**CONESTOGA-ROVERS
& ASSOCIATES**

December 15, 2014

Reference No.090476

Subject: Comments on the January 15, 2014 Feasibility Study
For the Confederate Park Site prepared by Geosyntec
Jacksonville, Florida
CRA Project Number 090476

Appendix G

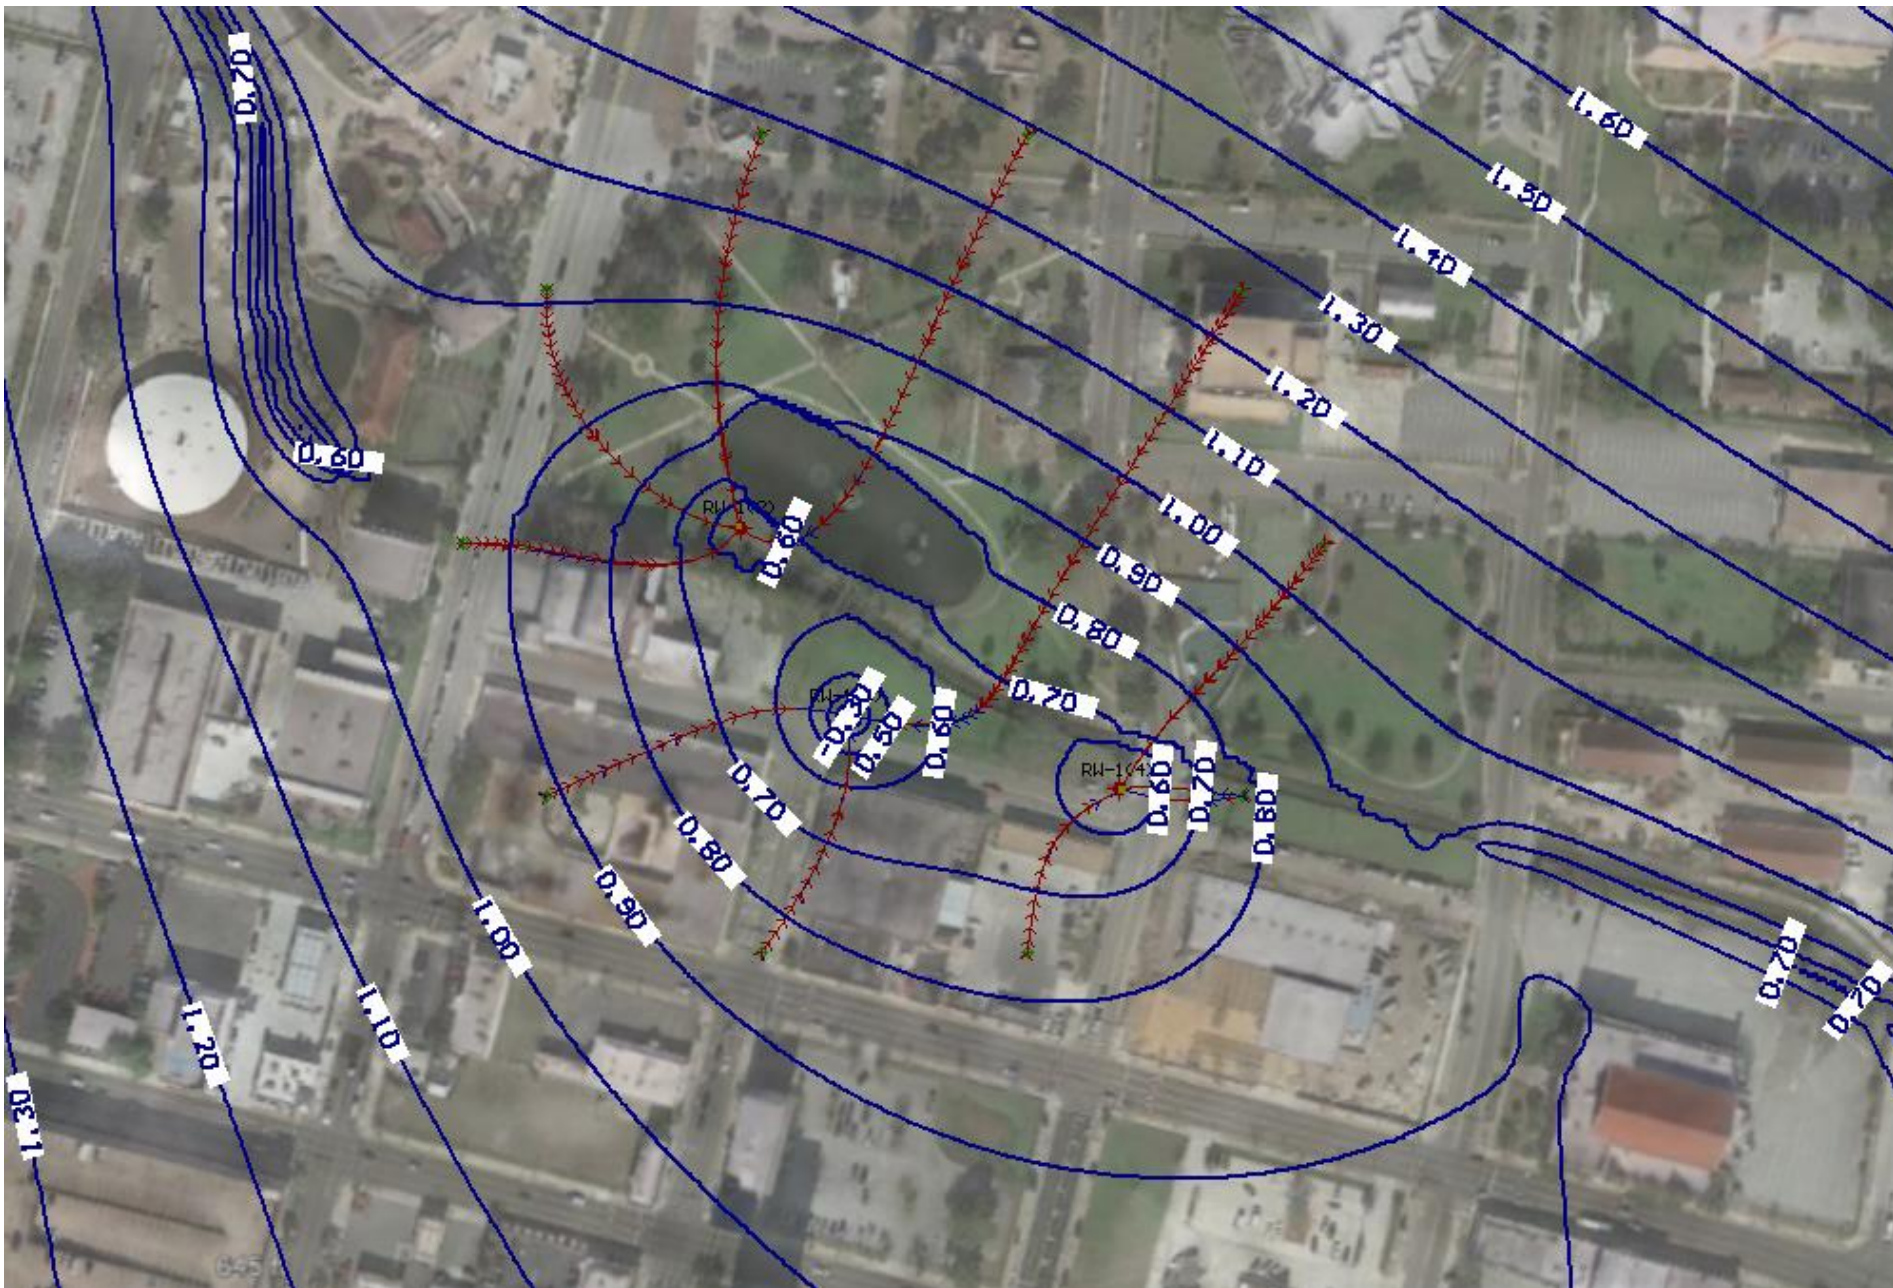
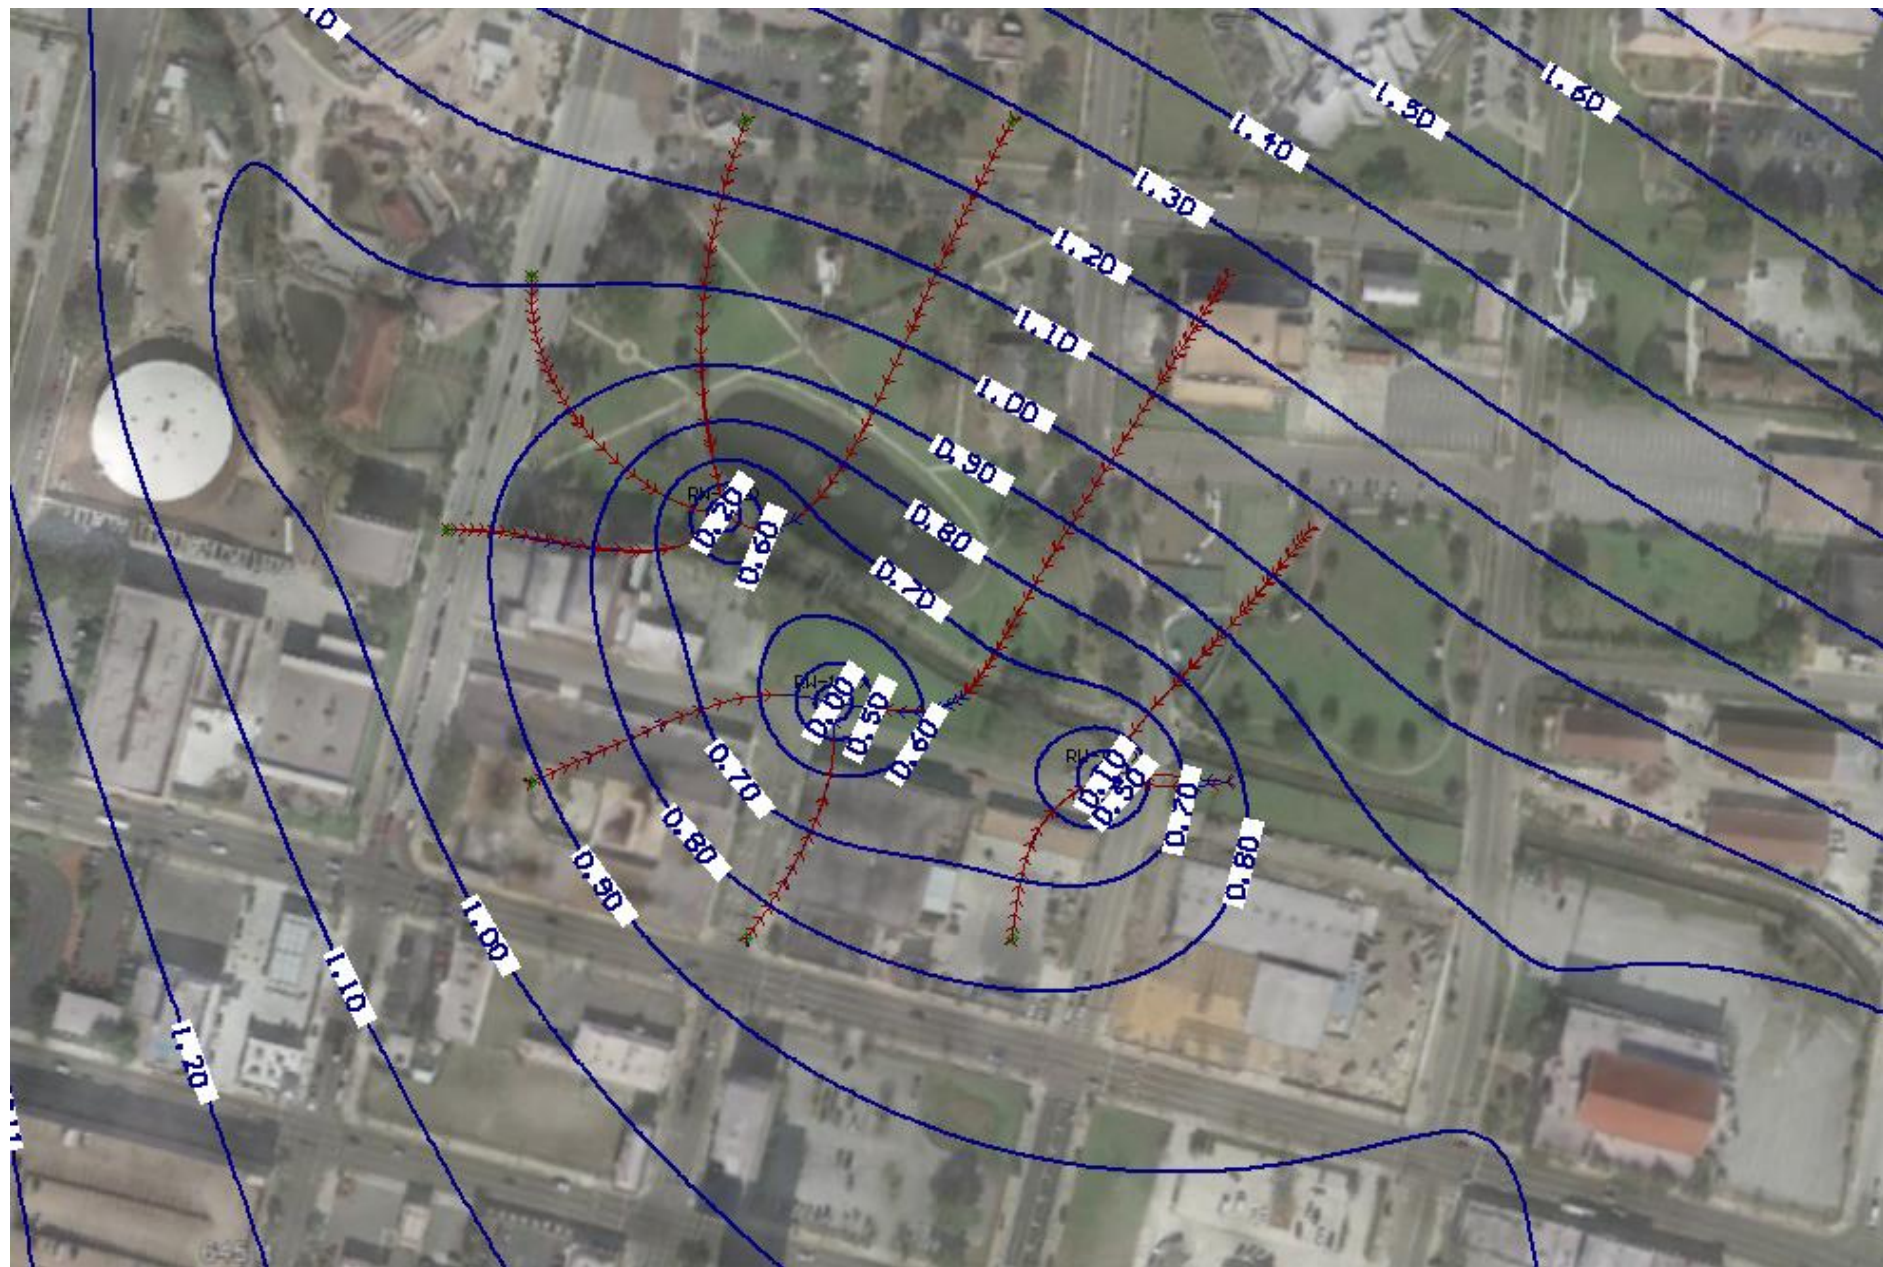
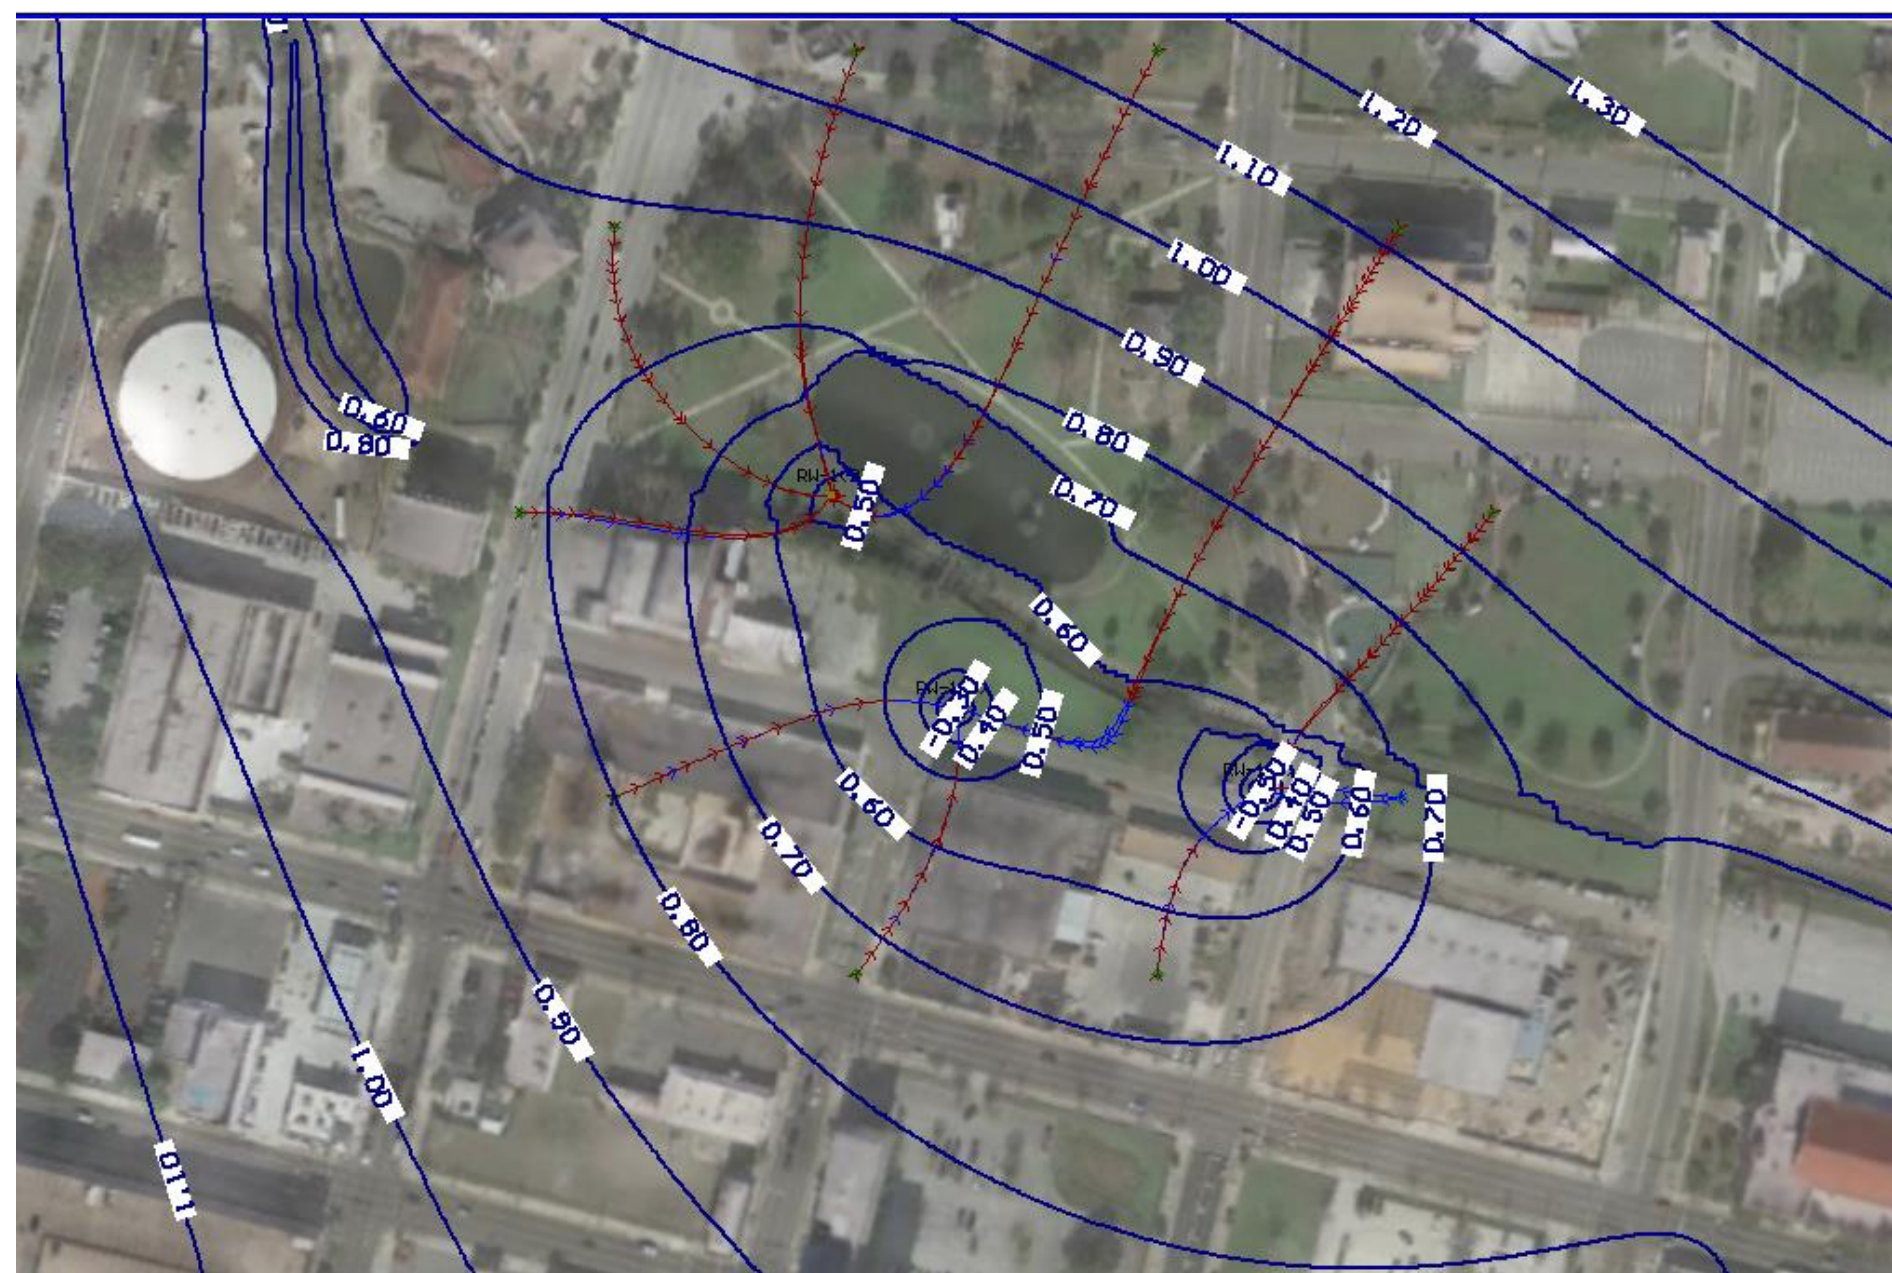
Instead of pumping from the decorative pond to maintain hydraulic control as proposed in the FS, the pond will be lined and three groundwater recovery wells will be used to capture the plume. CRA conducted feasibility-level modeling with sensitivity analyses by varying the hydraulic conductivity and pumping rate. The three-dimensional numerical model constructed with Visual MODFLOW that was used for the report entitled *Confederate Park Hydraulic Control Design Evaluation* dated November 2013 was used to simulate various groundwater recovery scenarios to assess hydraulic control of the dissolved plume. Modifications to the model included modeling the sides and bottom of the decorative pond with a liner (AquaBlok) using a hydraulic conductivity of 1E-9 centimeters per second (cm/s). The sides and bottom of approximately 375 meters of Hogan's Creek were also similarly modeled. The sides of the pond and Hogan's Creek were both simulated with the "wall" feature. The bottom of the pond and the creek were simulated by adjusting the vertical hydraulic conductivities associated with the MODFLOW "Lake" and "River" packages.

The recovery wells extend vertically to the deep zone through multiple layers of varying hydraulic conductivity. The recovery wells from the three-well model were all located southeast of the pond and north of Orange Street (**Appendix G**). The scenario was modeled using total pumping rate of 8.5 gallons per minute (gpm). The hydraulic conductivity of the unconfined aquifer (4.0 ft/day), which was determined by Geosyntec using tidal response data, was used for the model simulations. Importantly,

In order to determine the sensitivity of the model to changes in hydraulic conductivity, a range of hydraulic conductivities were modeled including 2.0, 10, and 19 ft/day. The hydraulic conductivity values were derived from the Site and nearby sites based on slug testing (i.e., PVI, geometric average from EHT, 7-11 Store (south of PVI), geometric average from Clara & Simon (south of Warren Partnership), and Horne Earl (northwest of Confederate Park), respectively). While these values are on the order of those derived using areal onsite data, they were derived from slug tests, which are not as reliable as the testing done on-site through the tidal analysis. The hydraulic conductivity was reported as 0.000581 ft/day using slug test at EHT site; however, after examining the raw data of the slug tests, CRA found that the units were reported incorrectly and the correction for the porosity of the filter pack was not conducted. After corrections, CRA estimated the geometric average of hydraulic conductivity as 3.1 ft/day at EHT. CRA also examined the underlying data from the slug tests at Clara & Simon site, and, in fact, two of the three slug tests used to calculate the 19 ft/d value were in error (including data associated with the sand pack instead of the formation itself – a common mistake). The corrected values yielded a hydraulic conductivity of approximately 5 ft/day. Hence, the data from across the area yield a tight dataset centering on 4 ft/day, which was the value used in CRA's modeling effort. Nevertheless, for sensitivity testing, the upper range, uncorrected values will be used as representing the bounds for the worst-case scenario.

Similar to the modeling results based on recovery of water from the decorative pond, the modeling results (hydraulic conductivity equals 4.0 ft/day) indicate that a flow rate of 8.5 gpm flow can effectively capture the groundwater plume. In fact, more groundwater is captured at this pumping rate than is required to encompass the entire plume, meaning that a reduction in this pumping rate may be possible during full-scale design by further optimizing the recovery well locations. The sensitivity analysis used a series of hydraulic conductivity values that indicated capture is feasible at 8.5 gpm. That is, if hydraulic conductivities range from 2 to 19 ft/day, a pumping rate of 8.5 gpm will still create sufficient drawdown to result in adequate plume capture, despite the increase in hydraulic conductivity. Because the goal of the hydraulic control is capture, this pumping rate is sufficient. The results of the CRA modeling are provided in **Appendix G**.

- The best estimate of hydraulic conductivity is 4.0 ft/d based on the tidal response data. At this rate, 8.5 gpm will capture the plume using three recovery wells. This pumping rate may be reduced by optimization during full-scale design.
- A sensitivity analysis using a series of hydraulic conductivity values ranging from 2.0 ft/day to 19 ft/day (i.e., the uncorrected values from nearby locations using slug tests) indicates that 8.5 gpm will capture the groundwater plume.
